wężyk do pompowania kół
65cm (średnica gwintu
6mm) kpl. Makita
TE00000345

Y08765

Title	Change of Motor assembly with Air pipe assembly
Model	MP100D
Country	All countries
Description	[1][2] Air pipe assemblies for production have been unified to ø6mm thread type. [3][4] Motor assembly for production have been changed according to [1][2]. Note: There is no difference in performance between ø6mm thread type and ø8mm thread type. However, the repairs are different. See below.

ø8mm thread ø6mm thread

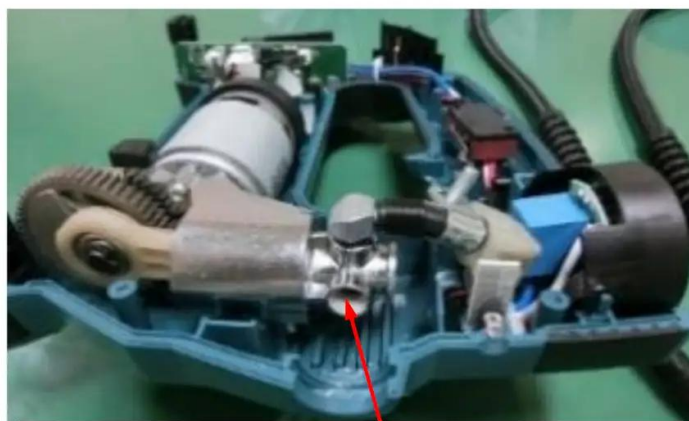
Current Air pipe assembly has either ø8mm or ø6mm threaded air pipe end as shown above.

New Air pipe assembly has the only ø6mm threaded air pipe end.

Only Air pipe assembly wants to be replaced;

Check the thread diameter of the machine that the customer repairs, and order the same Air pipe assembly.

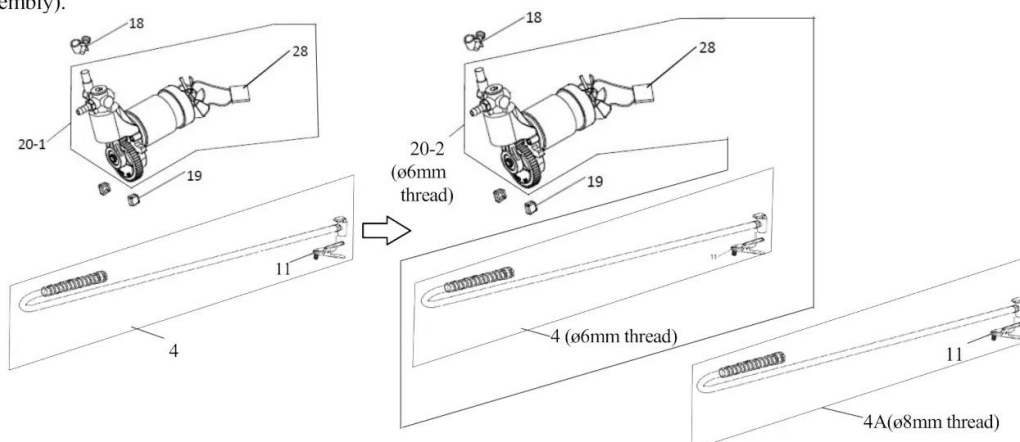
Current Motor assembly has either ø8mm or ø6mm thread joint portion.

New Motor assembly has the only ø6mm thread joint portion.

Motor assembly wants to be replaced;

Because of parts unification to ø6mm thread type, order the new Motor assembly (with ø6mm thread Air pipe assembly).
